**Planning Department
Transportation Development Services**

**Re: Parking Expansion for Dr. Haltom
10433 Lagrima De Oro
Traffic Circulation Layout
Engineer's/Architect's Stamp dated 7-28-15 (F21-D052)**

PARKING LOT EXPANSION FOR DR. HALTOM

SITE PLAN - TCL

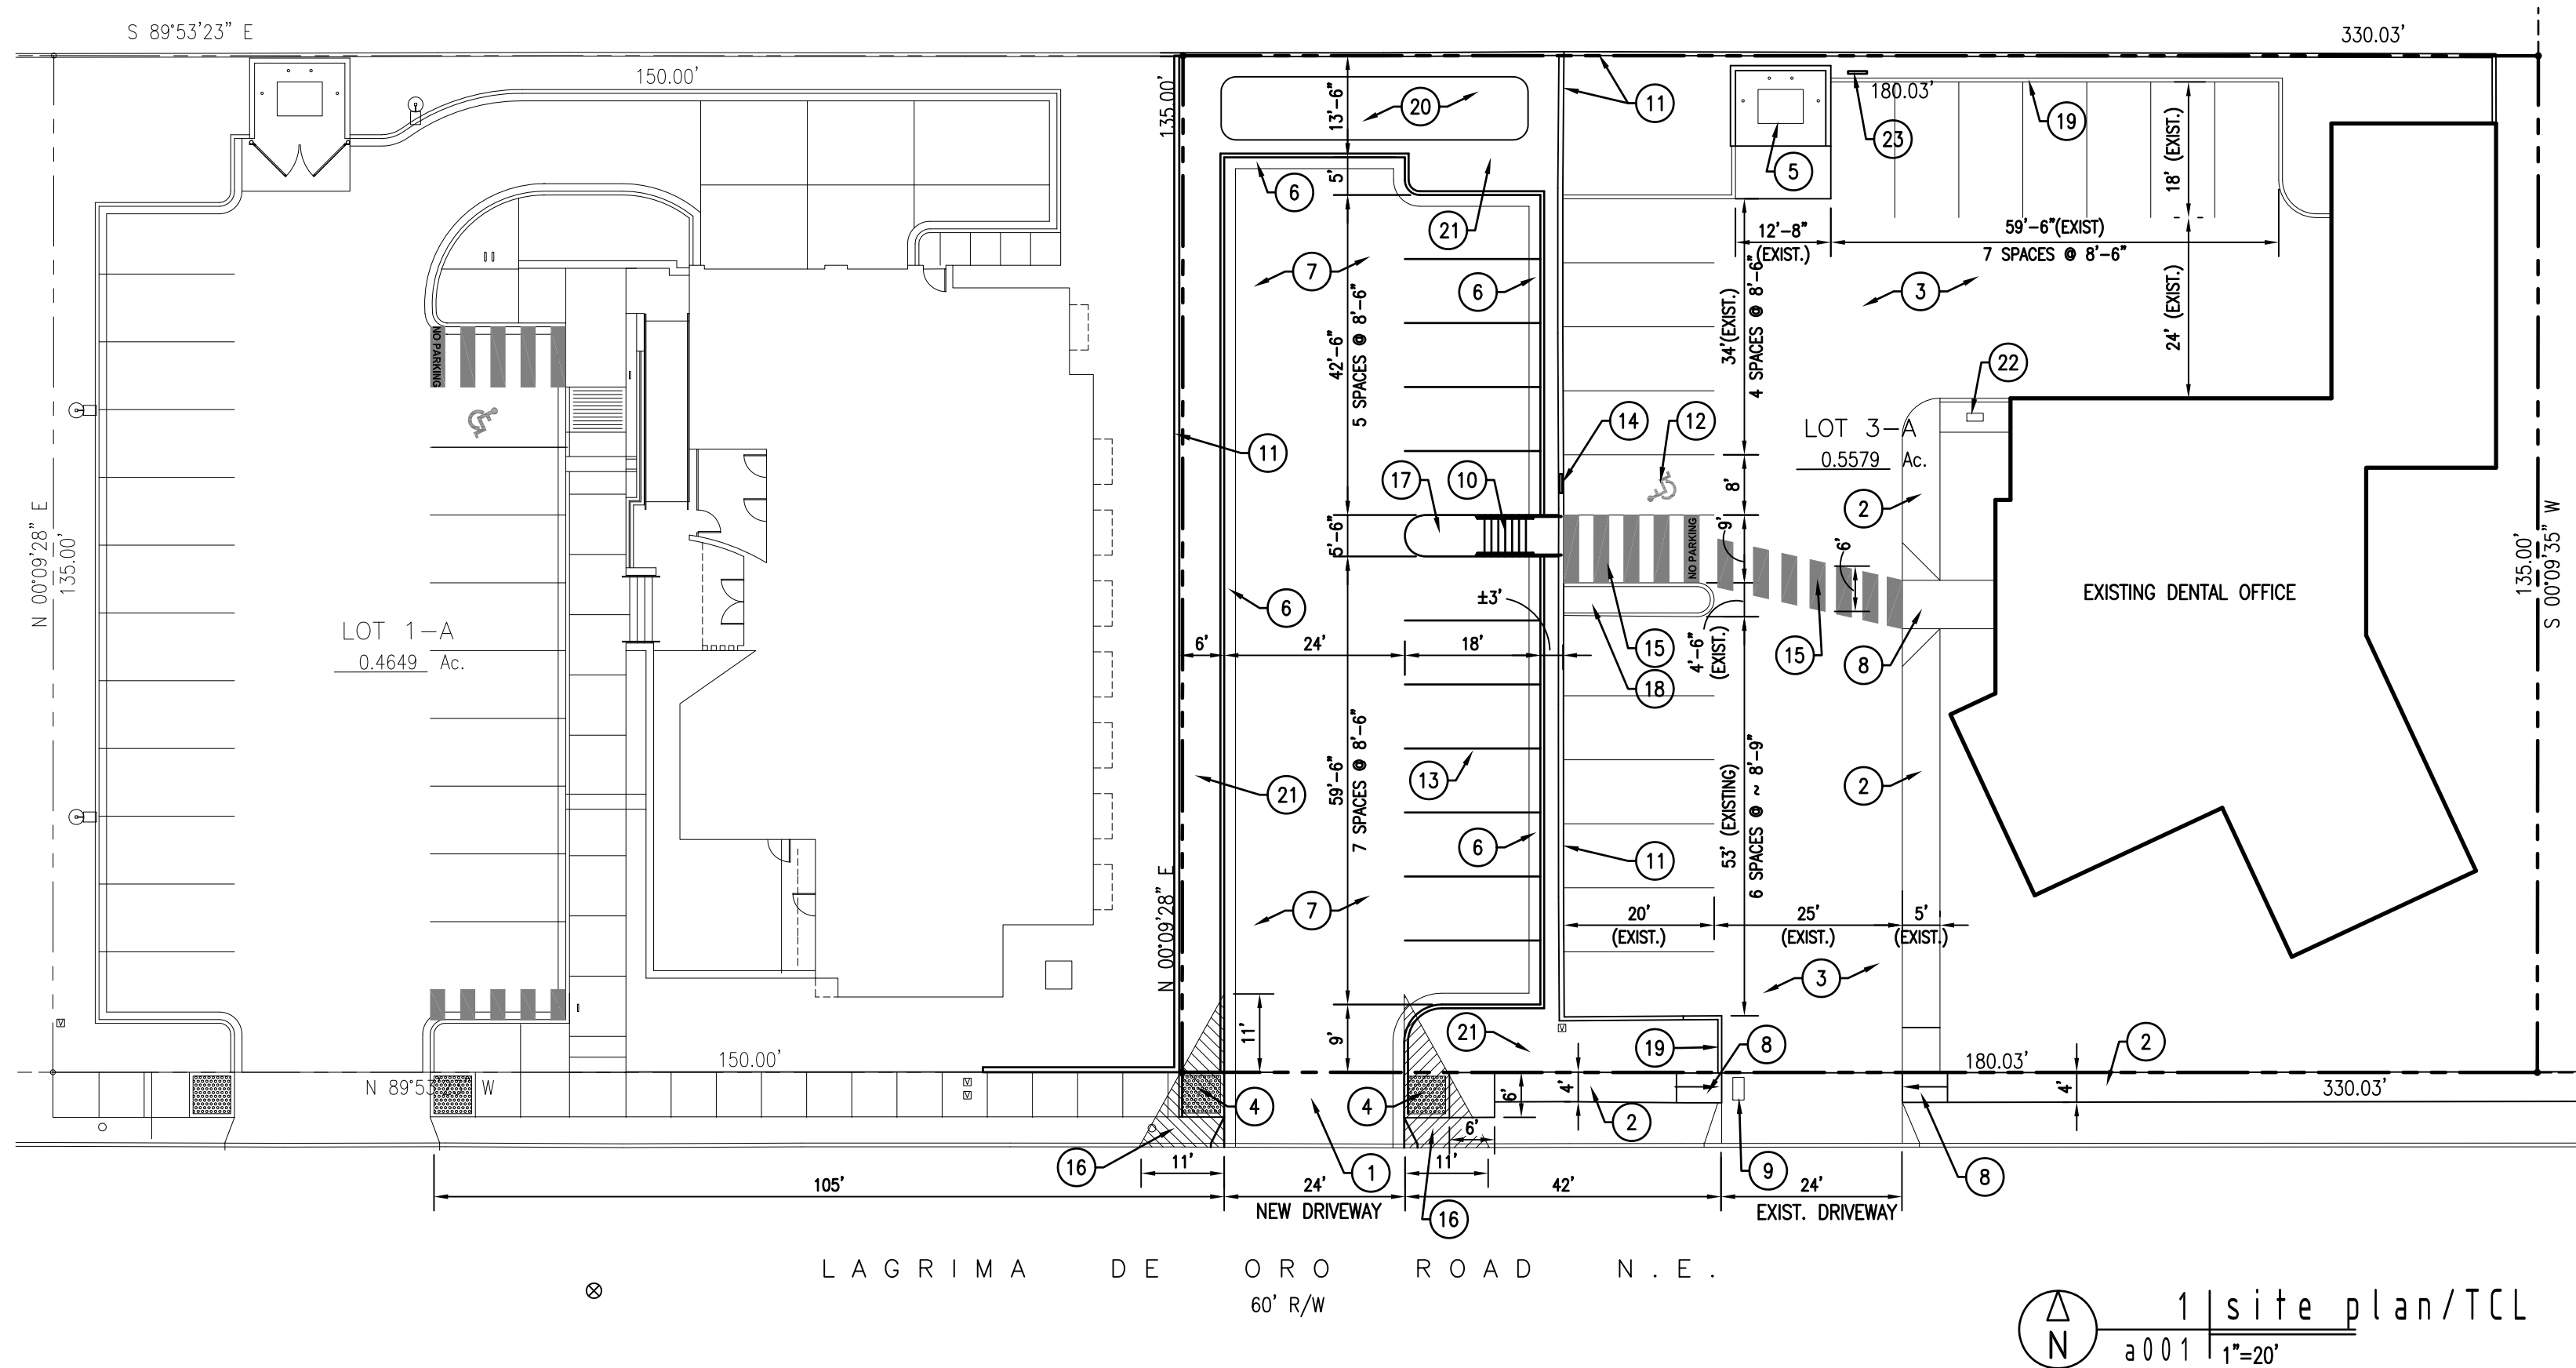
1. Clarify the extents of the development to the west of the existing building. Please detail property lines. If parcels have been re-platted, please provide documentation of platting action.
2. Due to the increase in parking spaces, an additional Handicap parking space will be required. Removal of the island south of the existing marked pedestrian walkway can accommodate the additional ADA parking space.
3. Please include a copy of your shared access agreement with the adjacent property owner, if applicable.
4. Please include two copies of the traffic circulation layout at the next submittal.
